# UNITED STATES PATENT AND TRADEMARK OFFICE

APPLICATION NO.	FILING DATE	FIRST NAMED INVENTOR	ATTORNEY DOCKET NO.	CONFIRMATION NO.
10/765,951	01/29/2004	Hubert Bucher	080404.53096US	1846

<b>Office Action Summary</b>	<b>Application No.</b> 10/765,951	<b>Applicant(s)</b> BUCHER ET AL.	
	<b>Examiner</b> Paul Devoti	<b>Art Unit</b> 3637

## **DETAILED ACTION**

Serden (DE 10135266) Figure 3

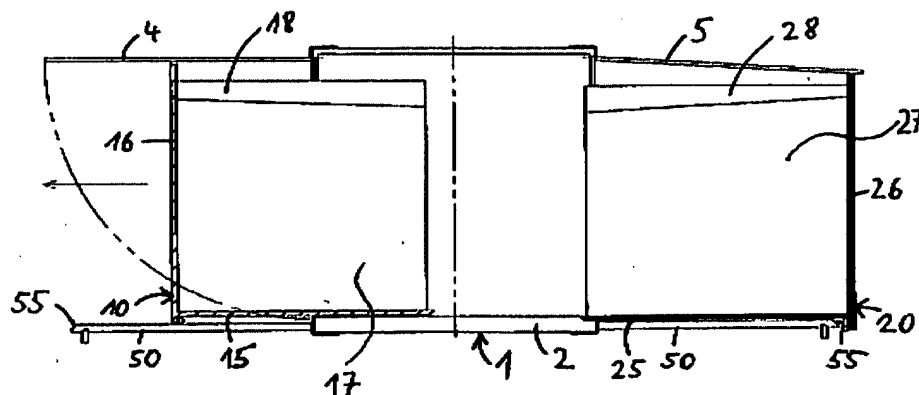
1. Claims 1, 2, 4, 8, 13, 15, 16, 19, and 20 are rejected under 35 U.S.C. 102(b) as being anticipated by Serden (DE 10135266).
2. Regarding claims 1 and 4, Serden (DE 10135266) discloses a container (1) having a floor wall (2), a roof wall (3), and a foldable side wall (5). An expansion element (20) is movable out of the container (1). The expansion element (20) comprises a floor wall (25), a side open to the container (1), and a front wall (26) opposite the open side. A roof wall is formed from the foldable side wall (5). A lifting device in the form of a winch or hydraulic cylinders lowers the expansion element (20) so that the floors of the expansion element (20) and container (1) are situated at the same level.

3. Regarding claim 2, the container (1) comprises an additional side wall and expansion element (10) that is movable out of the container (1) with the lifting device, in an opposite direction from the first expansion element (20). The expansion element (20) is movable into the expansion element (10) as seen in Fig. 2.

4. Regarding claim 8, surface elements (28) close gaps between the expansion element (20) and the foldable side wall (5), creating an interior space.

5. Regarding claim 13, a surface element (28) is vertically movable with respect to the side wall (27).
6. Regarding claim 15, the surface element (28) is connected to the expansion element (20), and when the expansion element is moved out of the container (1) in a path via the track (50), the surface element (28) is also guided in a path via the track (50).
7. Regarding claims 16 and 20, the ends of the surface element (28) inherently seal via contact between the surface element (28) and the expansion element (20) or container (1).
8. Regarding claim 19, the surface element (28) is foldable away from the foldable side wall (5) of the container (1).

Stout (US 2167557) Figure 3

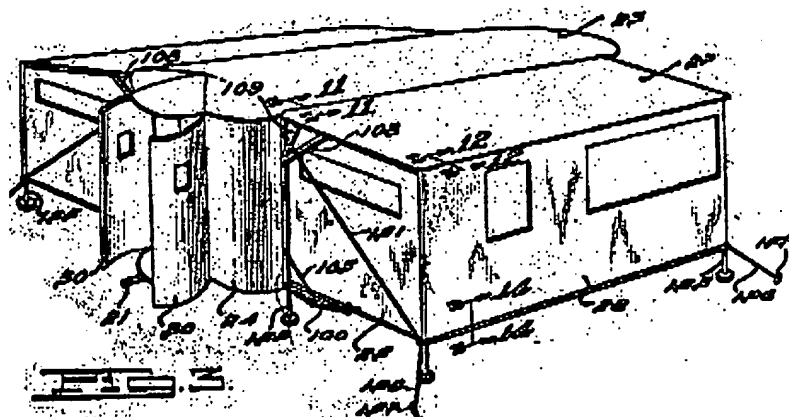
10. Regarding claims 1 and 4, Stout discloses a container structure having a floor wall, a roof wall (23), and a foldable side wall (27). An expansion element is movable out of the structure. The expansion element comprises a floor wall (26), a side open to the structure, and a front wall (28) opposite the open side. A roof wall is formed from the foldable side wall (27). A lifting device (a winch device as seen in Fig. 16) lowers the expansion element so that the floors of the expansion element and container structure are situated at the same level.

11. Regarding claim 3, tracks (110) are provided on the foldable side wall (27) to guide the expansion element.

12. Regarding claim 7, the winch device (in Figure 16) comprises two cables (121 and 136) and helps move the expansion element into position.

13. Regarding claims 5 and 6, rollers (111) are attached to the expansion element and inherently act as traveling carriages which are guided in the track (110). As the rollers (111) move in the track (110), they help guide the expansion element out of the structure, which in turn guides the cables.

Molina (US 5921033) Figure 7

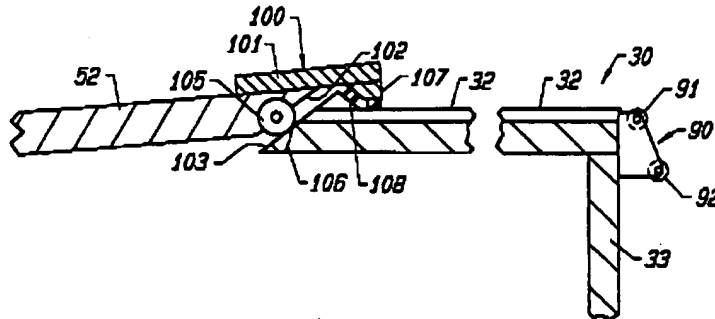
16. Regarding claims 9, 14, and 17, Serden (DE 10135266) discloses everything previously mentioned, but does not disclose the surface elements have a multi-shell construction. Molina, however, discloses an expandable structure having a surface element (100) with a multi-shell construction (101, 107). Therefore, it would have been obvious to one having ordinary skill in the art at the time of invention to modify the

surface elements of Serden to have a multi-shell construction as taught by Molina, as the two layers would provide a better seal for the expansion elements of the container.

Stout (US 2167557) Figure 12

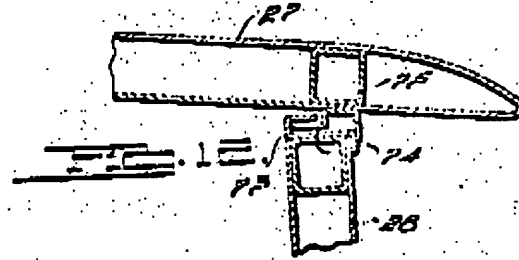
18. Regarding claims 10 and 18, Serden in view of Molina discloses everything previously mentioned, but does not disclose a surface element rigidly fastened to the foldable side wall. Stout, however, discloses a trailer comprising a surface element (74) rigidly fastened to a foldable side wall (27). Therefore, it would have been obvious to one having ordinary skill in the art at the time of invention to modify Serden's container, already modified by Molina, to include a surface element rigidly fastened to the foldable said wall, as taught by Stout to seal between a foldable side wall and an outer wall section.

Fig. 6

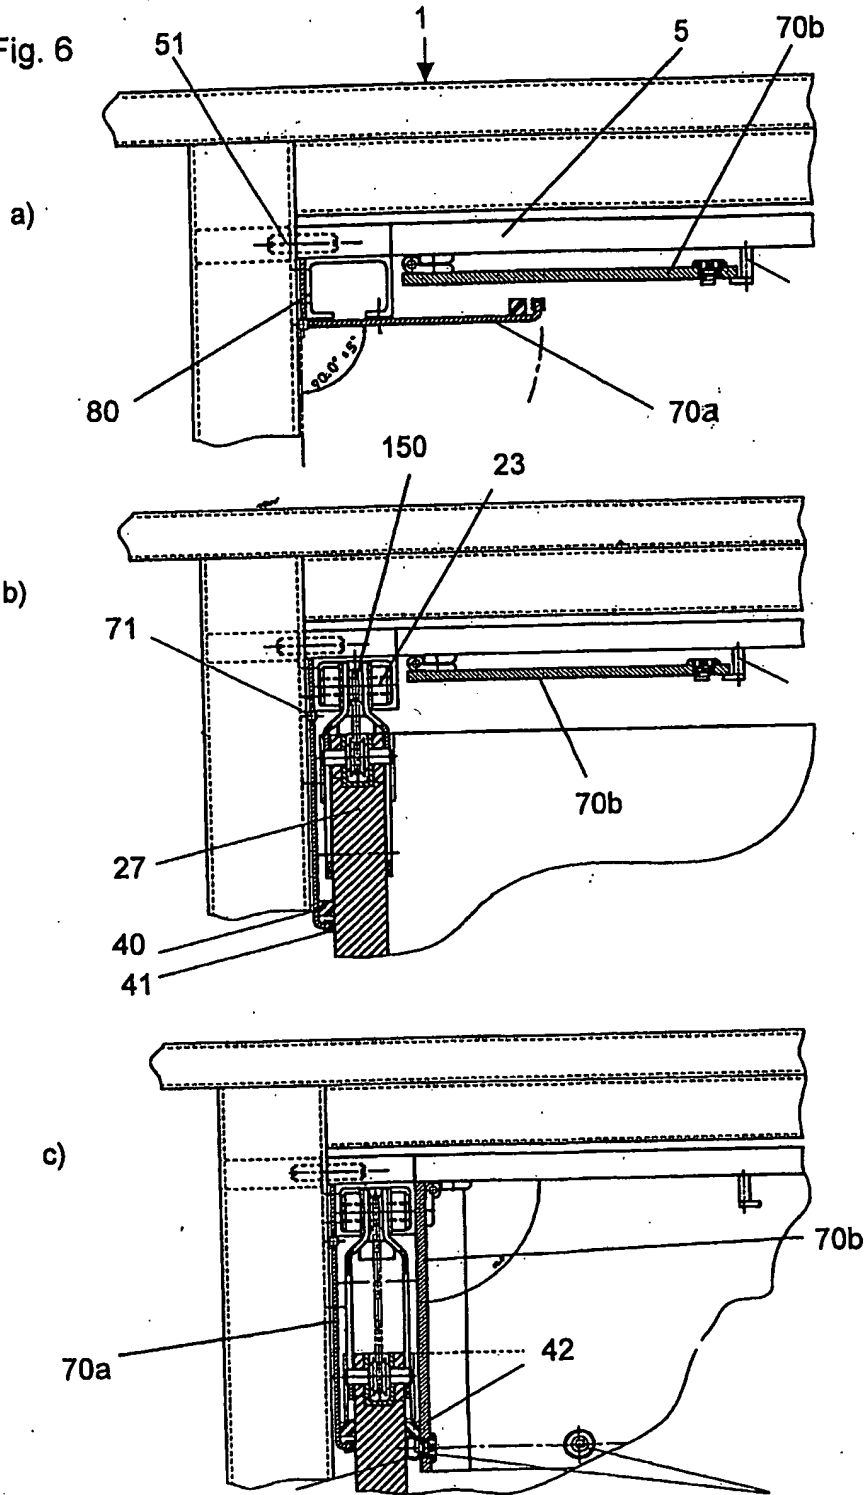
OK to  
Enter.
